Test results

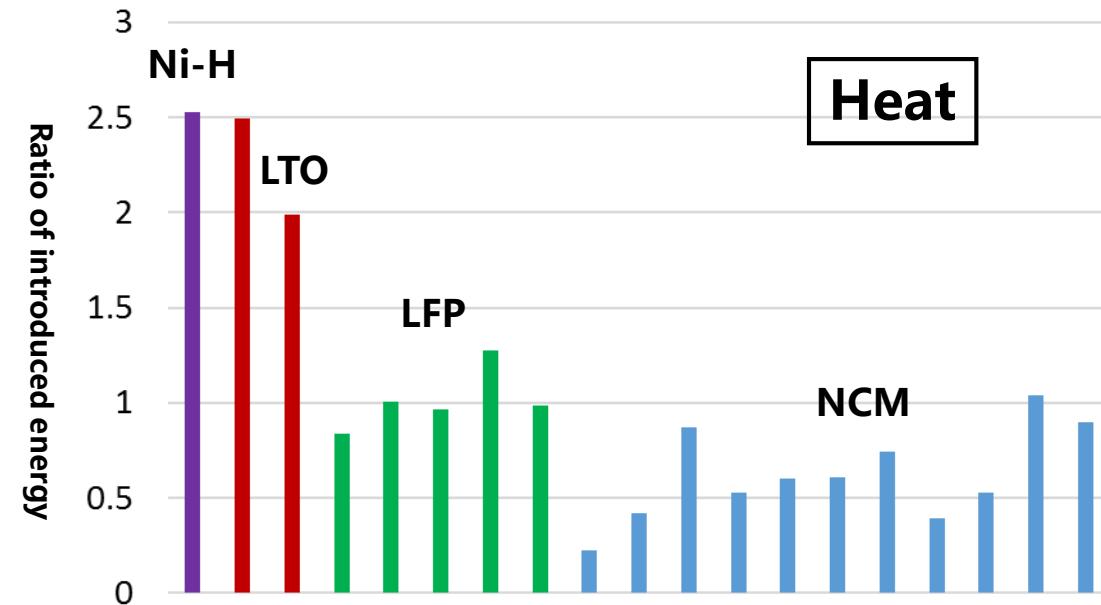
Can you specify
the equation here

Test results

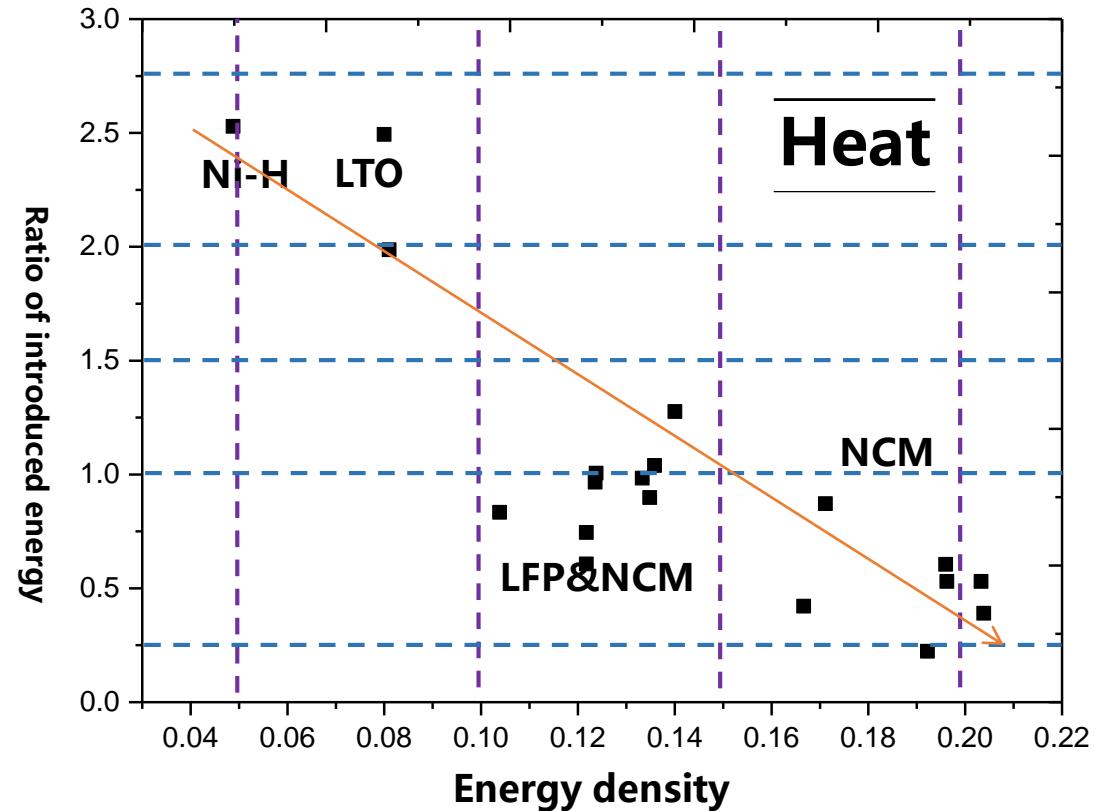
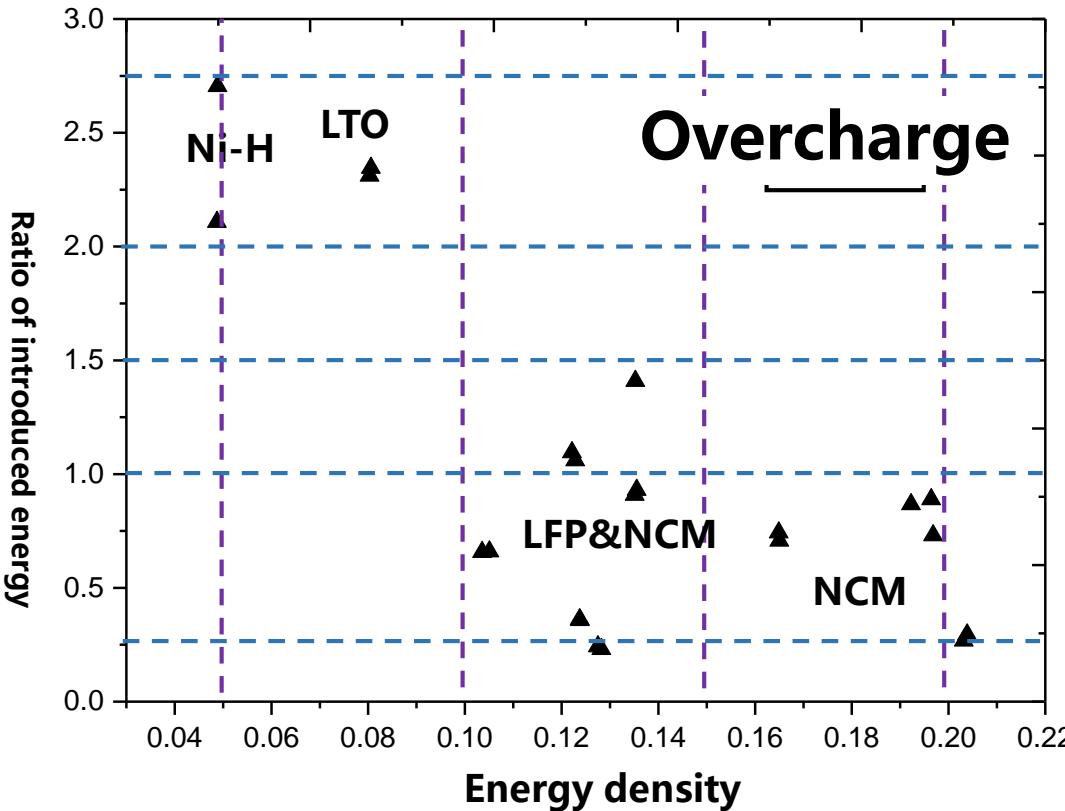
Have you compared pouch vs prismatic during external heating? The cell format will influence this trend.
